**From:** John Drabble  
**Sent:** 05 December 2018 13:56  
**To:** Rob Smith  
**Cc:** Robert Staniland; Mark Bates  
**Subject:** Woodsmith Mine - Application for Hazardous Substances Consent - LNG Compound Layout Update

Woodsmith Mine  
Section 96a  
LNG / Generator Plant  
Sections

Woodsmith Mine  
Section 96a  
LNG / Generator Plant  
Compound

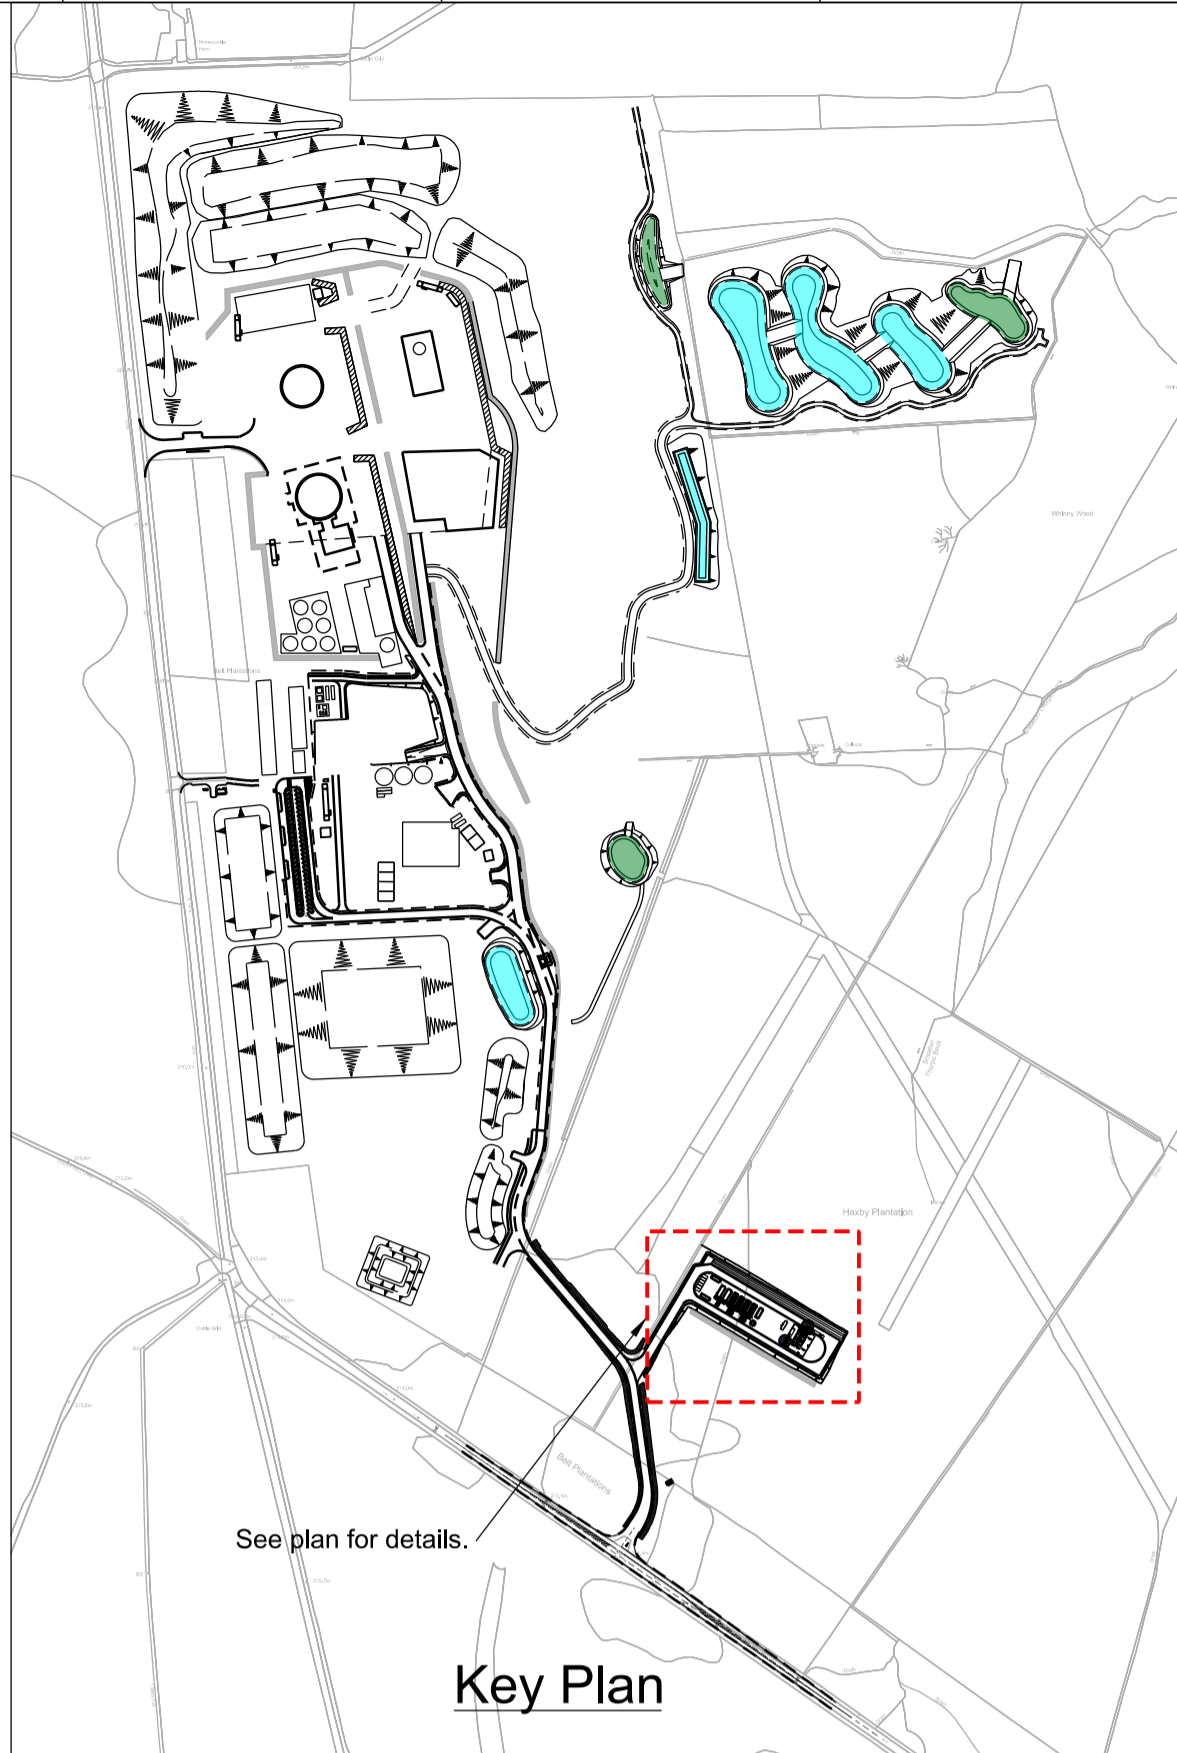
- A revised lighting scheme;
- The removal of fire water and foam storage tanks; and
- The introduction of a 3m timber screening fence at the south-western boundary of the site.

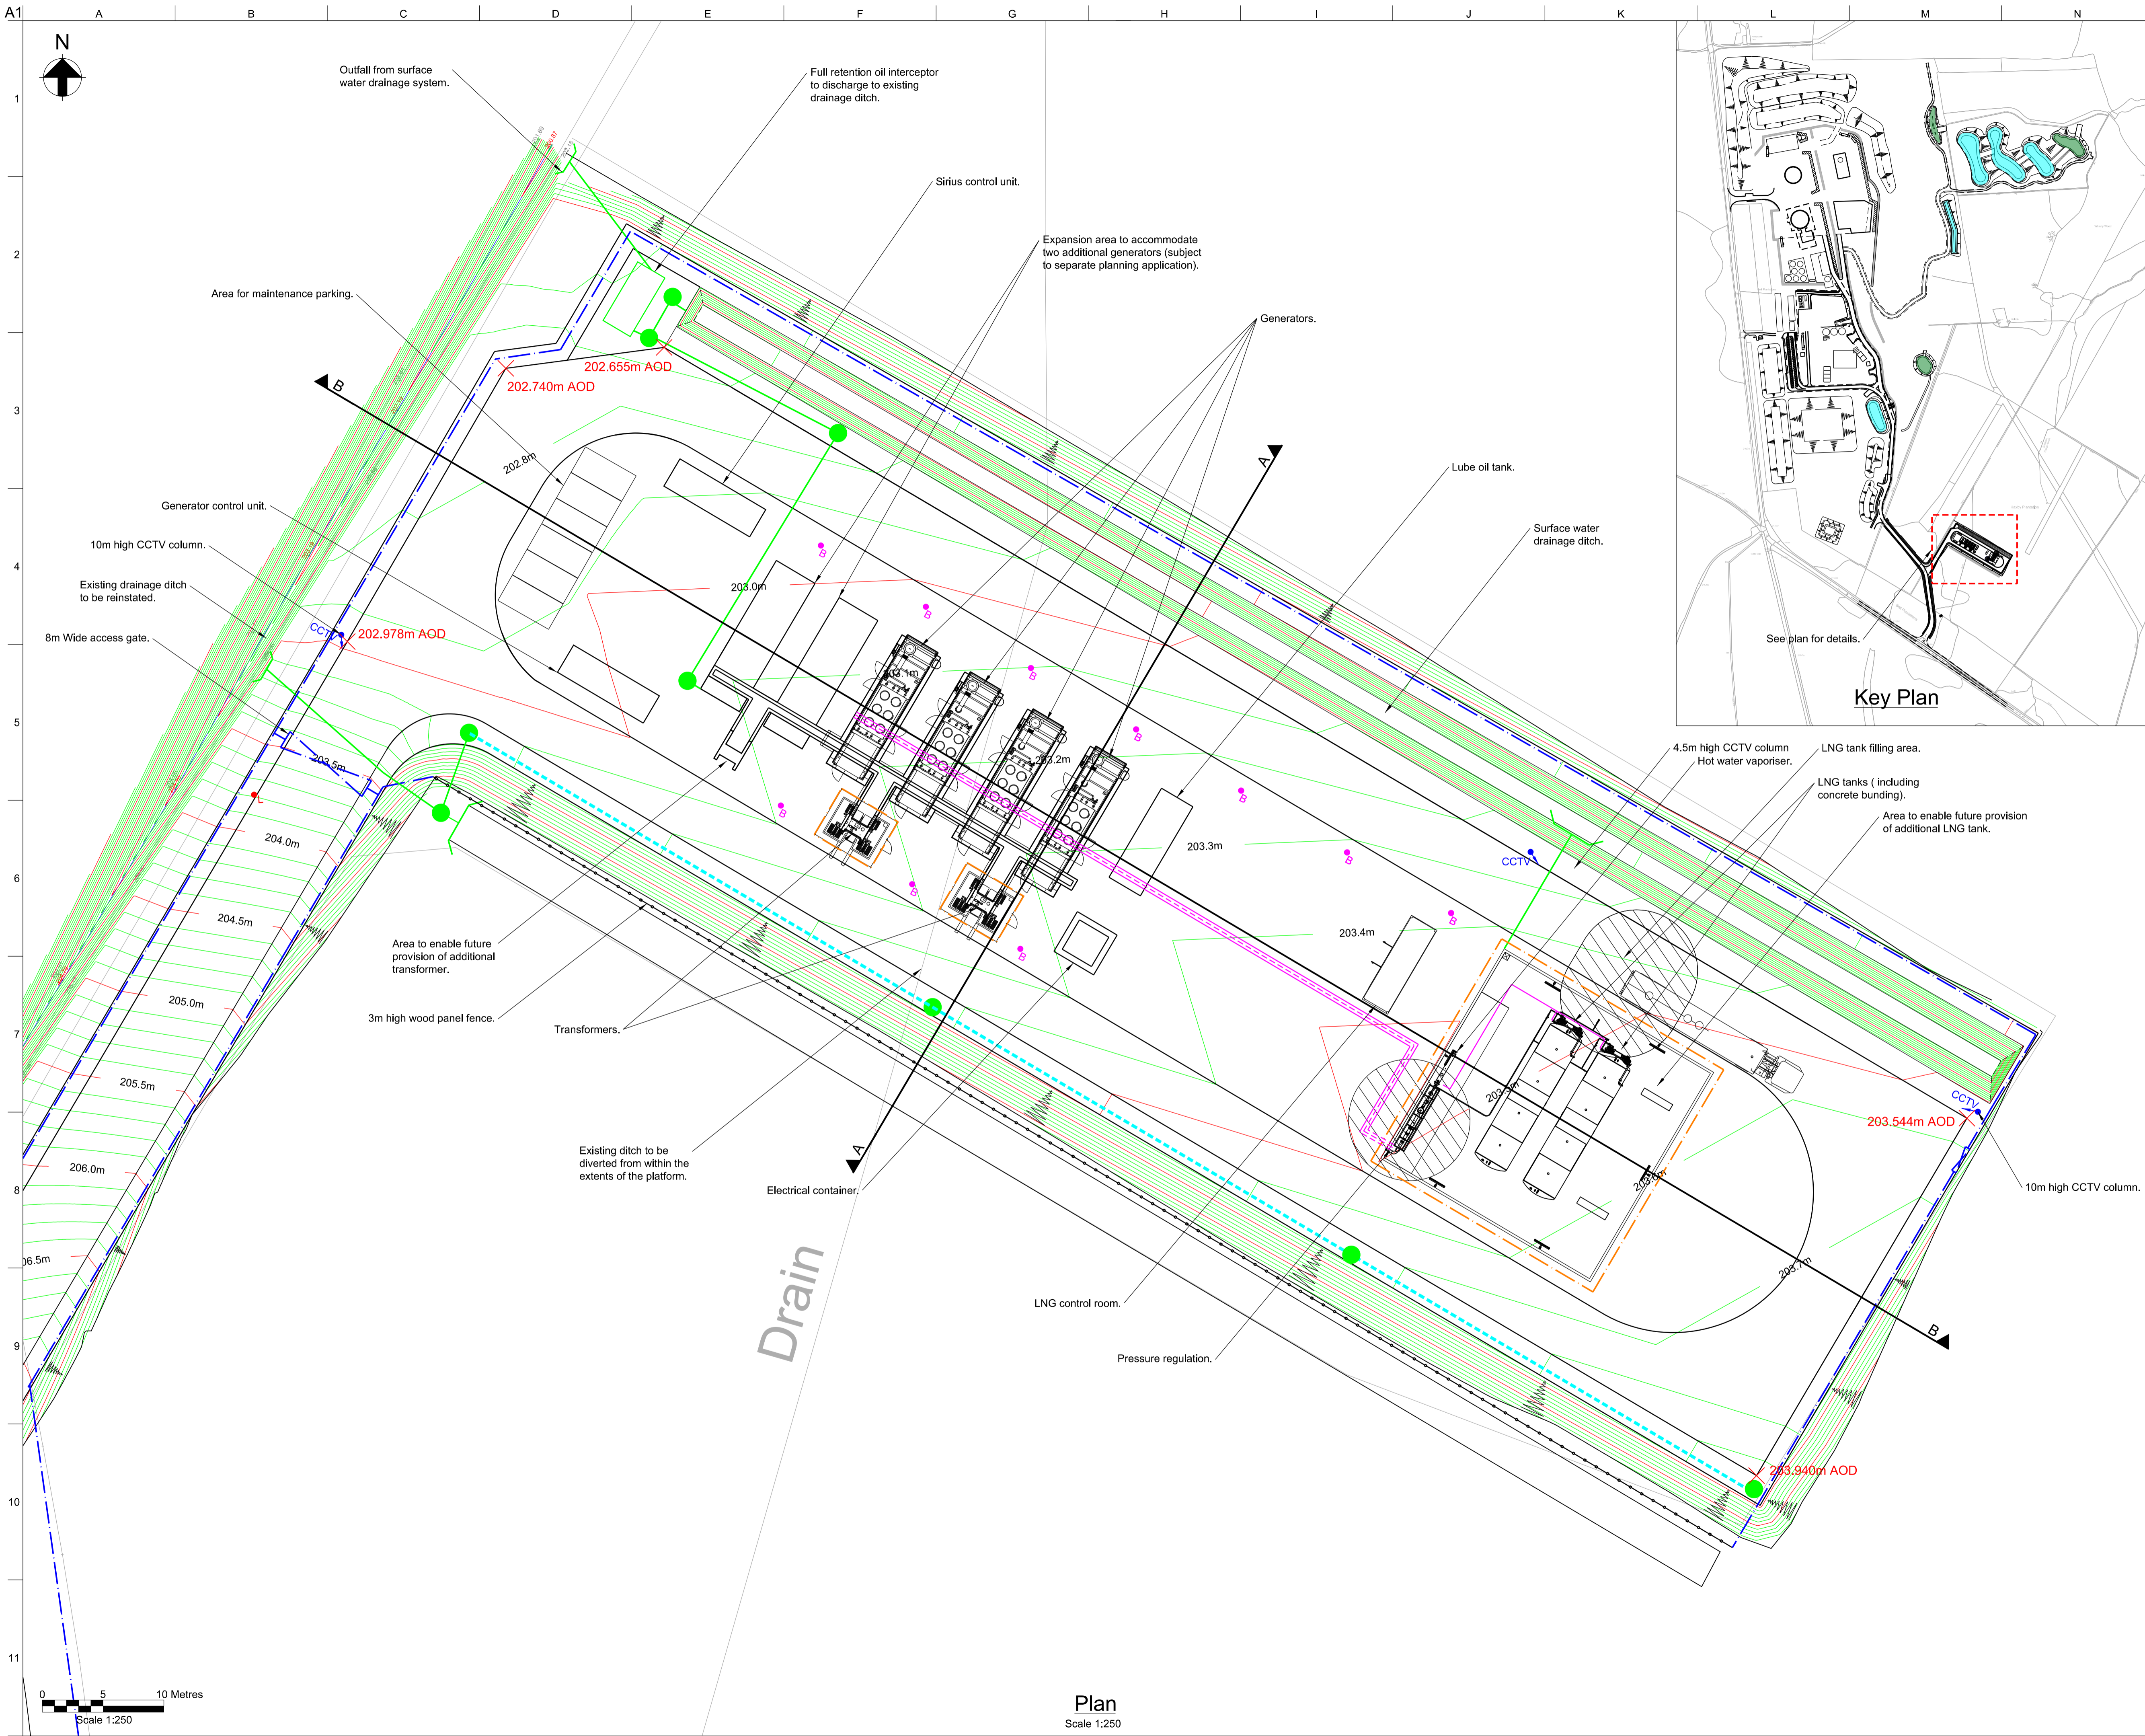
scheme and screening fence are to address initial queries in respect of the planning considerations, given the location within the National Park. The water and foam storage tanks were included as a presumption in the initial design, but following detailed QRA (quantified risk assessment) and Hazop (hazard and operability study) procedures in the detailed design stage, it was concluded that the risks of a release and then ignition would be extremely low. On the basis of the risk assessments Sirius have concluded that the risk is sufficiently low that a dedicated fire suppression system for the LNG compound is not required. The Hazop conclusions were that industry good practice for a LNG facility in a remote area does not require a fire suppression.
